## ADDENDUM NO. 2

**Re:** Greenburgh CSD Capital Improvement projects at Highview ES; Lee F Jackson ES; RJ Bailey ES; Woodlands MS HS; Early Childhood Program

**BBS Project #21-288; 21-289; 21-290; 21-291; 21-292**

ROOF DEMOLITION AND PROPOSED PLAN  
HIGHVIEW ELEMENTARY SCHOOL

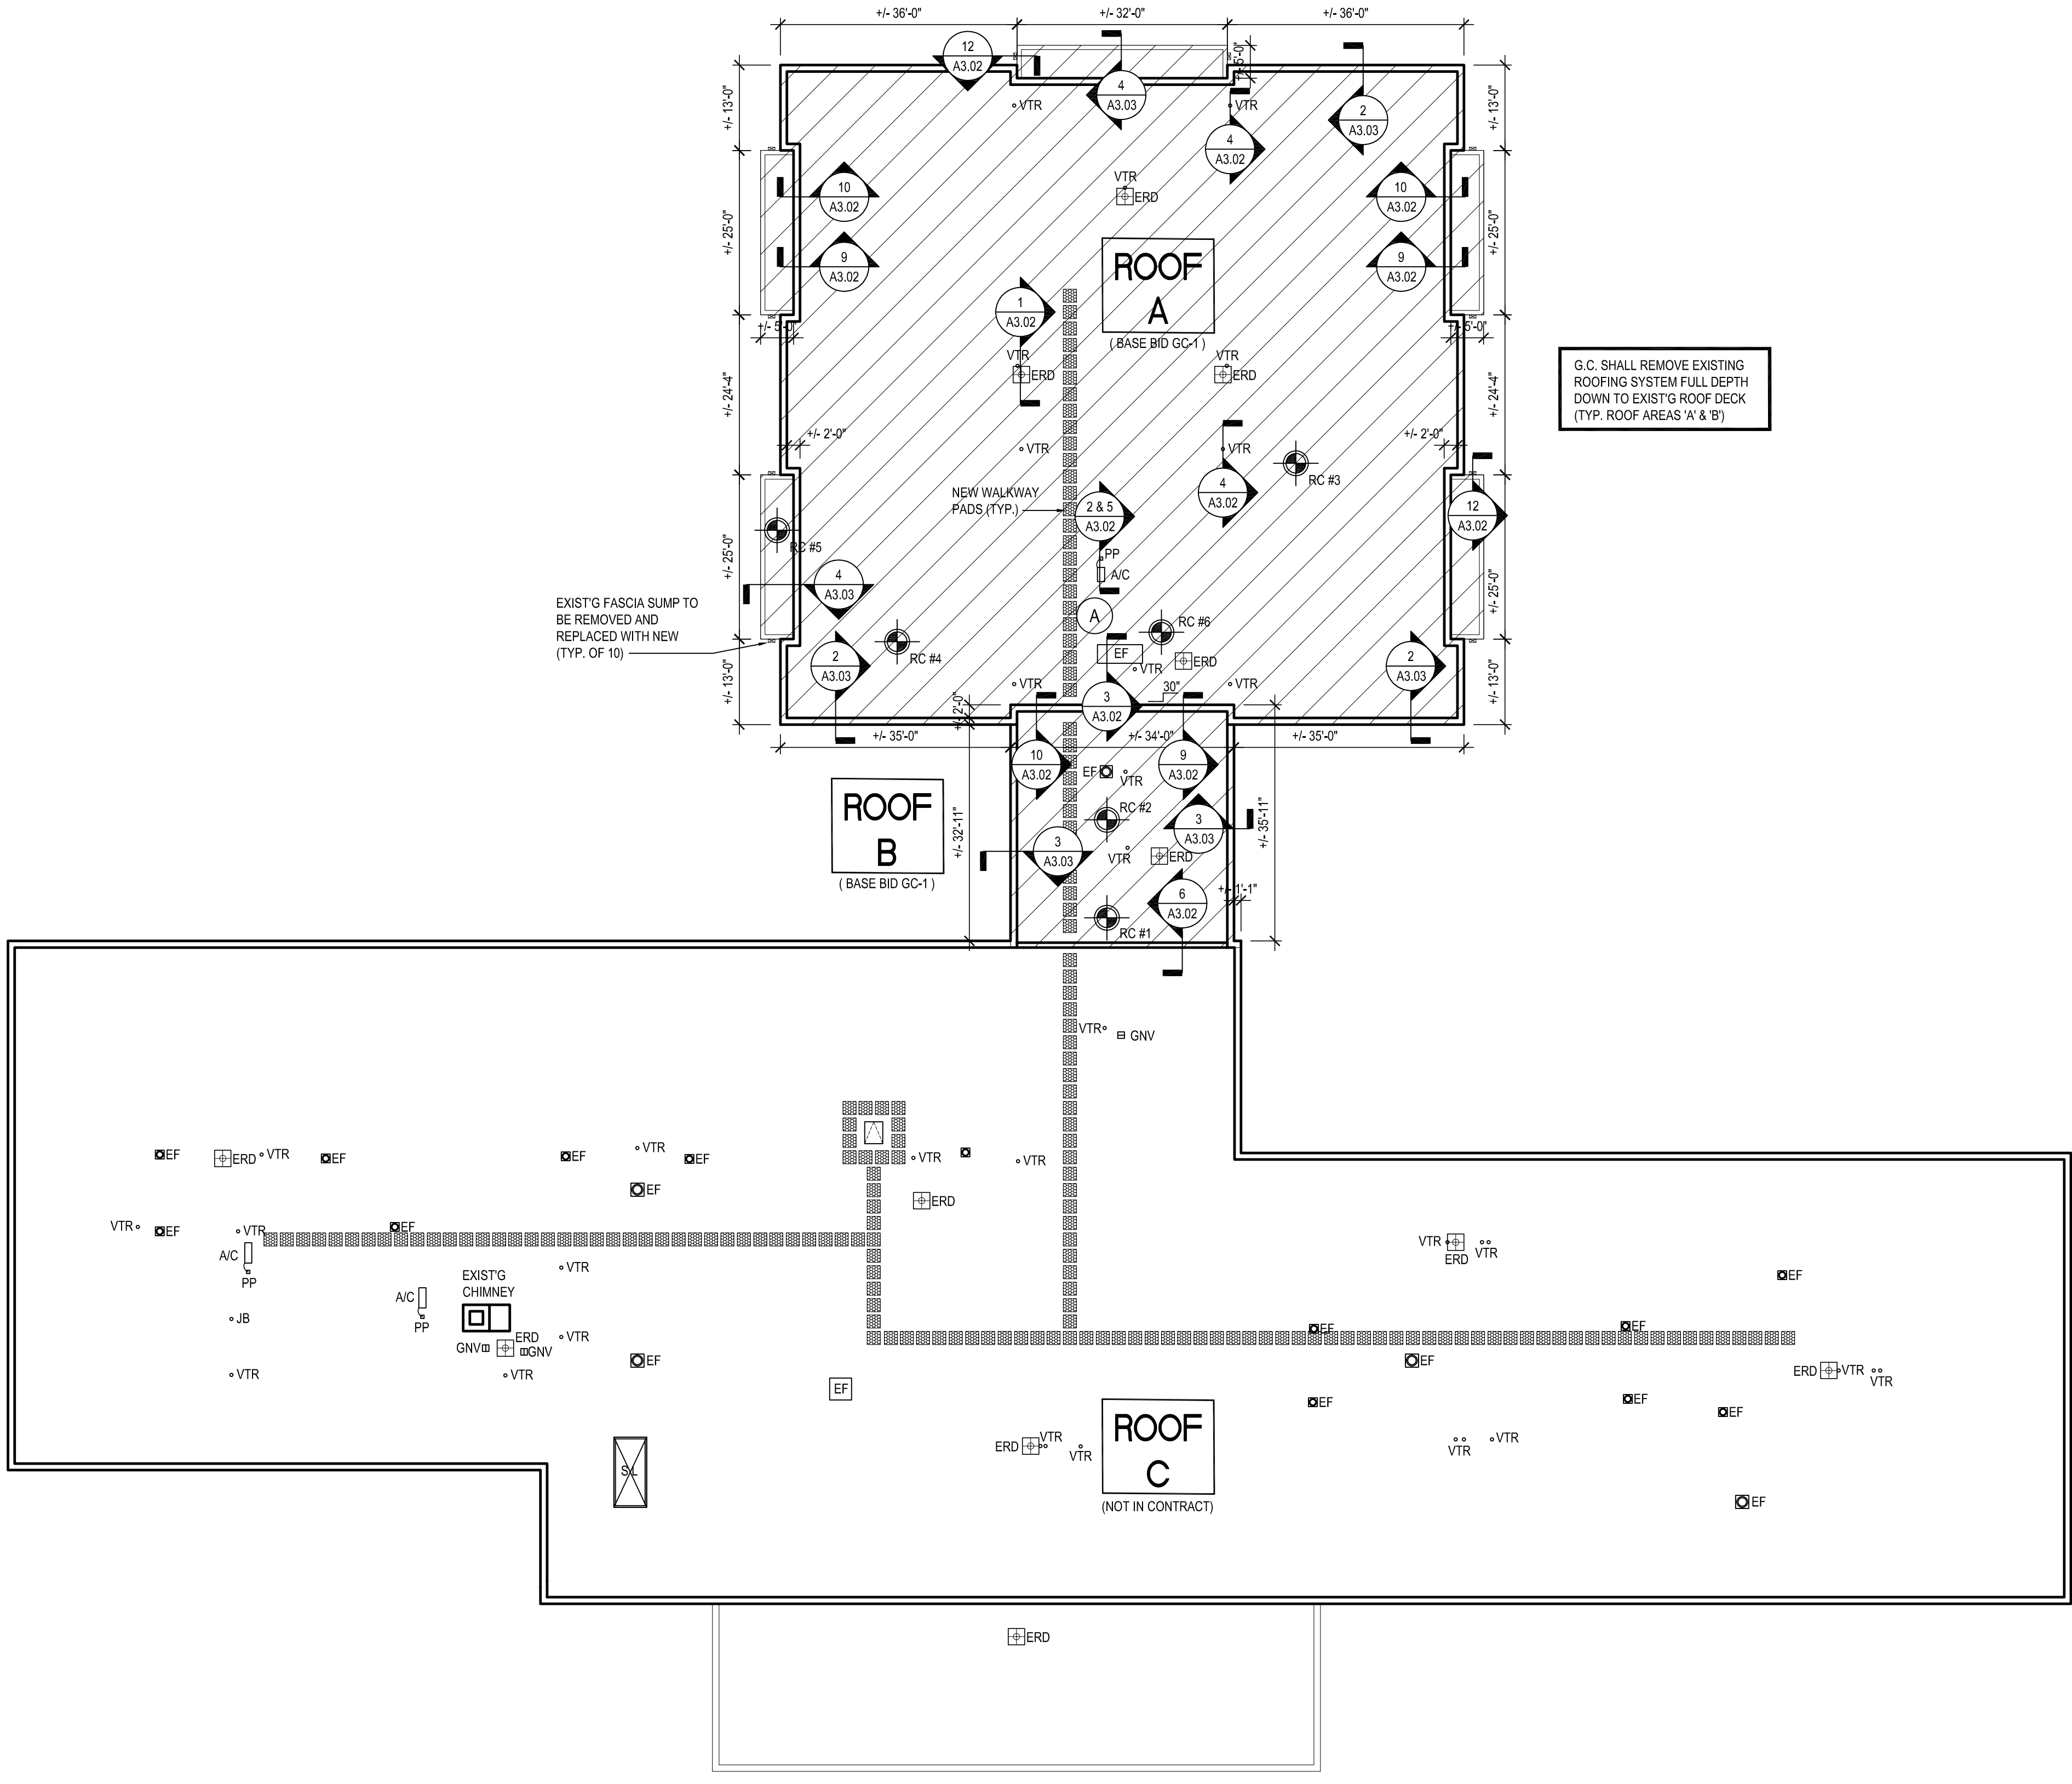
1. **Sheet A3.01A** – Roof details roof area A
  - a. Roof edge detail shown as both detail 2 and 10 on sheet A3.02 show 2 different roof edge conditions. The correct roof edge condition is detail 2 / A3.02.
